**COVERING NOTE TO LPP06 REPORT OF CHRISTOPHER ROSS, CONSULTANT PLANNER  
DATED 19 NOVEMBER 2024**

**SUBJECT:** 301/182 KURRABA ROAD, KURRABA POINT  
**APPLICATION NO.** D138/24  
**AUTHOR:** ISOBELLA LUCIC, A/MANAGER DEVELOPMENT SERVICES  
**DATE:** 26 NOVEMBER 2024

**PROPOSAL:** Installation of a Vergola on the Rear Balcony

**Figure 4 – Proposed North Elevation**

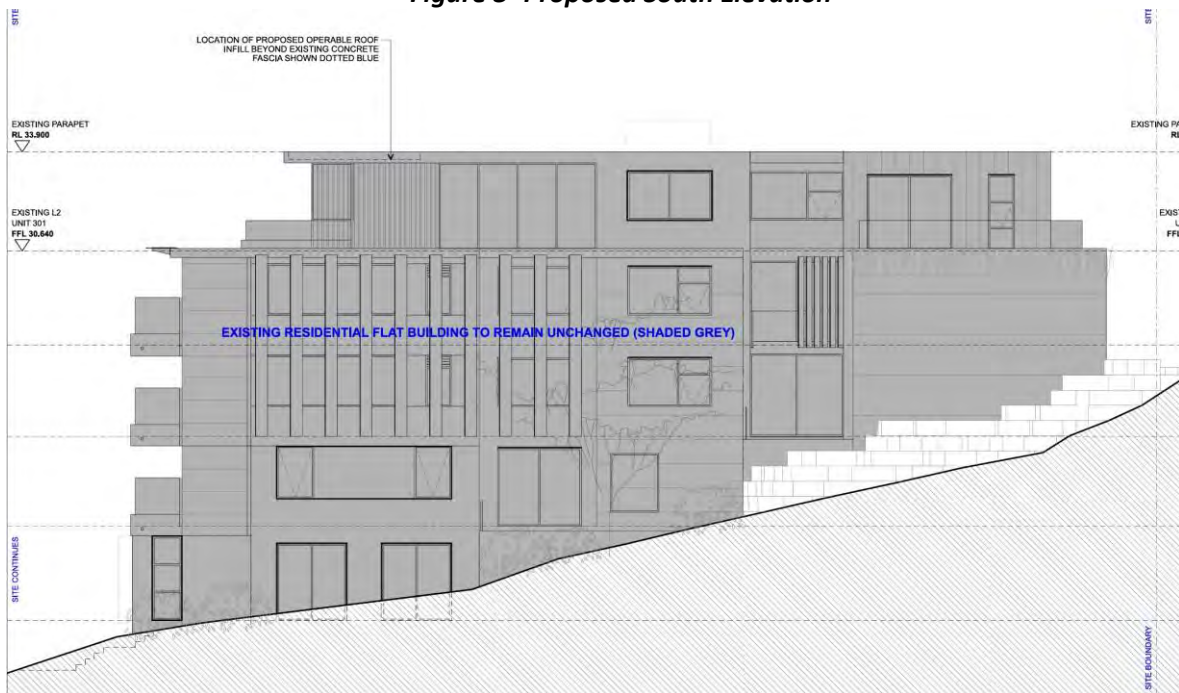
The applicant has provided a Clause 4.6 exception to development standards written request that details the applicant's assertion that compliance with the height of buildings development standard is unreasonable or unnecessary in the circumstances of the application. Further assessment is provided under the relevant heading.

Figure 10 – Extract of Approved Plan DA\_100\_50 Rev. 05 per DA 333/19/2

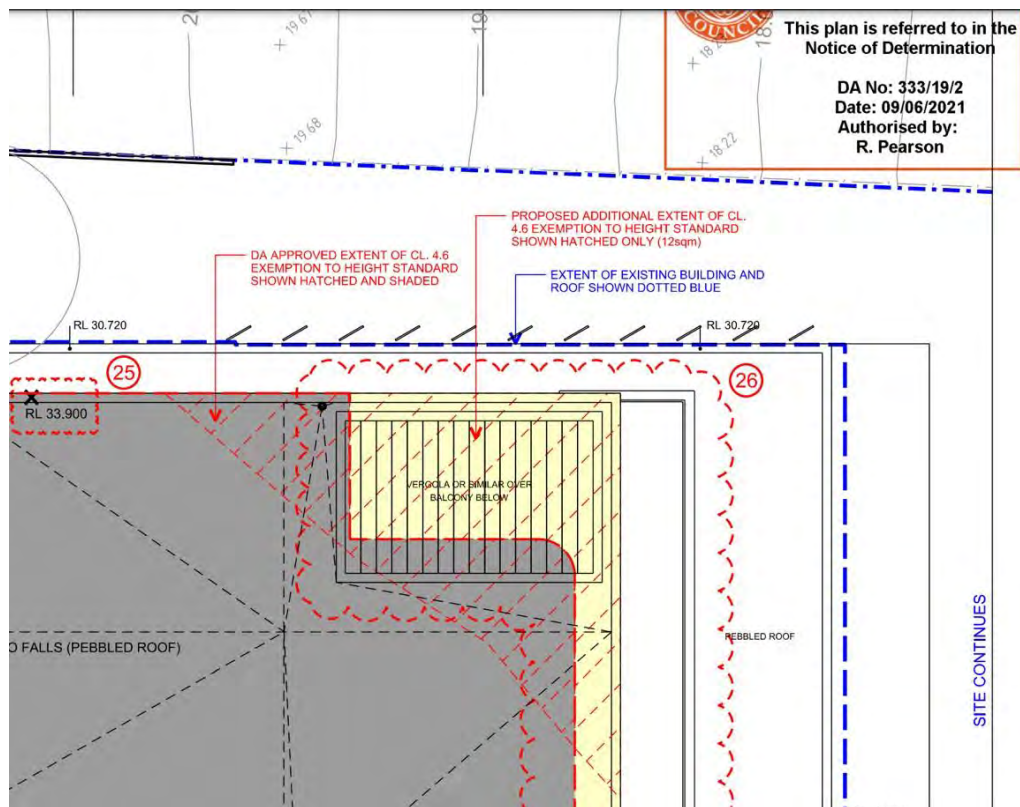
An extract of the plans approved under DA 333/19/2 is provided at **figure 10**. It is noted that the plan labels the vergola as the internal element within the framing.

**Figure 11 – Extract of Approved Plan DA\_100\_50 Rev. 13 per DA 333/19/4**

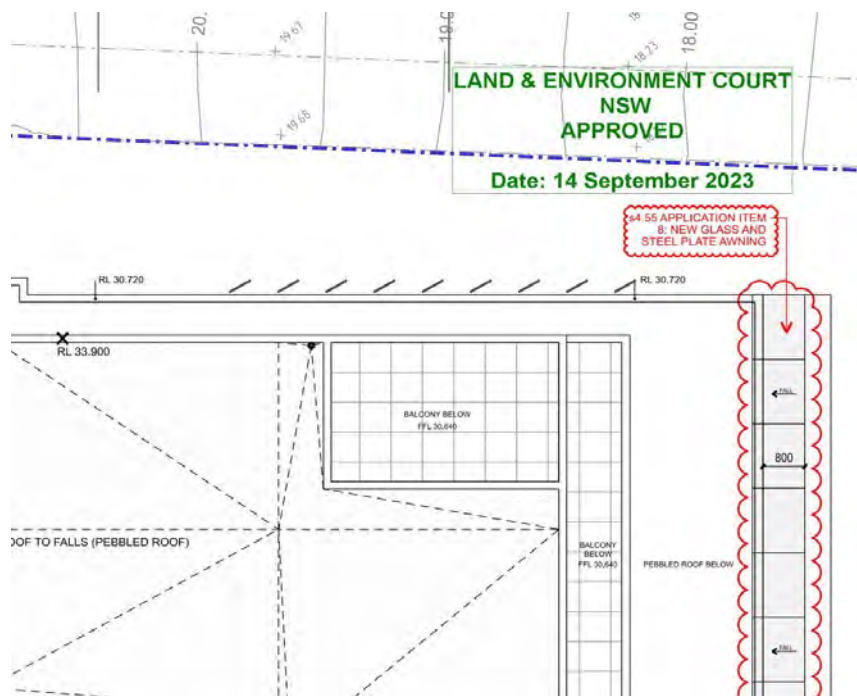
An extract of the plans approved under DA 333/19/4 is provided at **figure 11**. It is noted that the plan has removed the infill vergola and reduced the 1.6m overhand to 0.8m in accordance with the wording of the condition. Again, the framing is retained and is an assumed approved structure per the consent issued in relation to DA 333/19/2. This appears to be supported by the consent issued for DA 333/19/4.

On review of both mentioned modifications, the framing to which the vergola subject to this application is proposed to be fitted within was shown as a roof element and subsequently approved on the plan sets. Refer **Figure 12** for photograph of existing balcony and roof frame.
